SERVICE BULLETIN

SUBJECT: INCREASED CHAIN ADJUSTMENT FOR NOSE LANDING GEAR RETRACTION MECHANISM (MOD N553)

Rework to Upper Chain Guard Figure 2

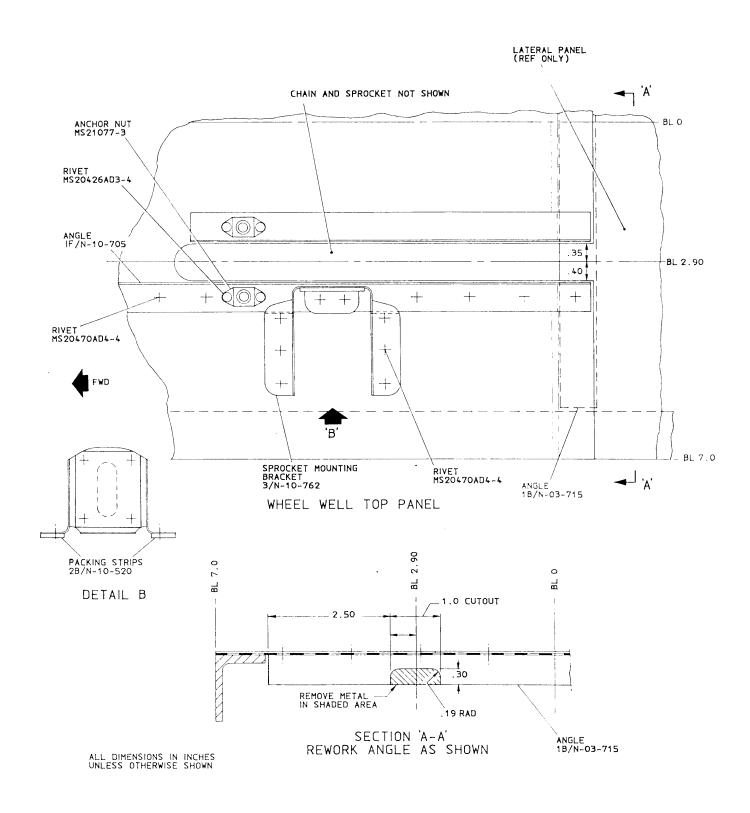
- J. Rework the Upper Chain Guard P/N 1/N-40-296 (Ref Fig 2).
 - (1) Mark out the area of metal to be removed from the top surface of the upper chain guard (Ref Figure 2 detail A) and remove the metal within the shaded area.

- (2) Position the cover plate over the cut out in the upper chain guard as shown in Figure 2 and, using the pre-drilled holes in the cover plate as a guide, drill ten 2.45 mm dia holes through the cover plate and upper chain guard.

- (3) Deburr the rivet holes and rivet the cover plate to the upper chain guard using rivets P/N MS20470AD3-3.
- (4) Open up the existing slots in the left hand side of the upper chain guard to the dimensions shown in Figure 2, detail B. After rework of chain guard re-identify with new P/N 1A/N-03-715.
- K. After all drilling and reworking of existing parts is complete ensure that all swarf and waste metal has been removed from the rework area.
